September 12, 2012

RE: Response to EPA Questions/Comments
PCB Cleanup and Disposal Notification under 40 CFR 761.61 (a)(3)
Physical Plant Renovations 2nd Floor, Room 230A

FIGURE 1 – SITE DIAGRAM (PCB SAMPLE LOCATIONS)

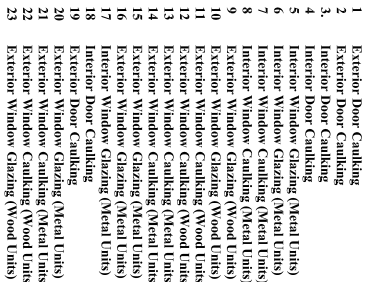
2. *All information required under 761.61(a)(3) was not provided. For example, a figure showing the sample locations and extent of contamination was not provided in accordance with 761.61(a)(3)(i)(C).*

Refer to **Attachment A** for the Figure 1 Site Diagram that shows the sample locations for the initial source sampling.

REVISED SITE LAYOUT DRAWING

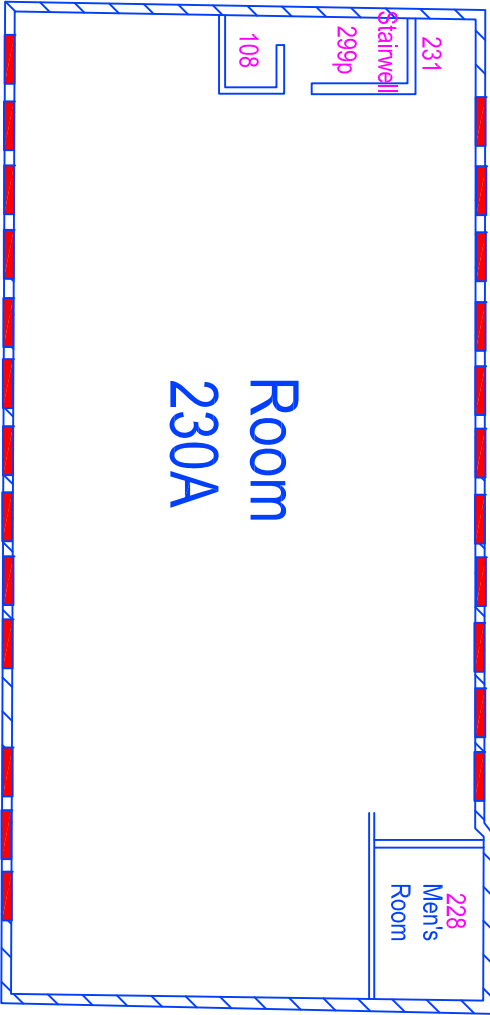
1. *Page 1. There is a reference to Attachment A for the location of Room 230A. In reviewing the Attachment A diagram, there is no location labeled Room 230A. Clarification should be provided showing what area is presented by this designation.*

- b. *The diagram provided in Attachment A requires clarification with respect to the extent of the 2nd floor designated at Room 230A. It would also be helpful if the locations of the window units to be removed are identified in color as the "dashed line" is difficult to distinguish on the diagram.*

Refer to **Attachment C** for the revised Site Layout Drawing that shows Room 230A.

Refer to the attached revised Site Layout Diagram that shows the locations of the window units to be removed and replaced.
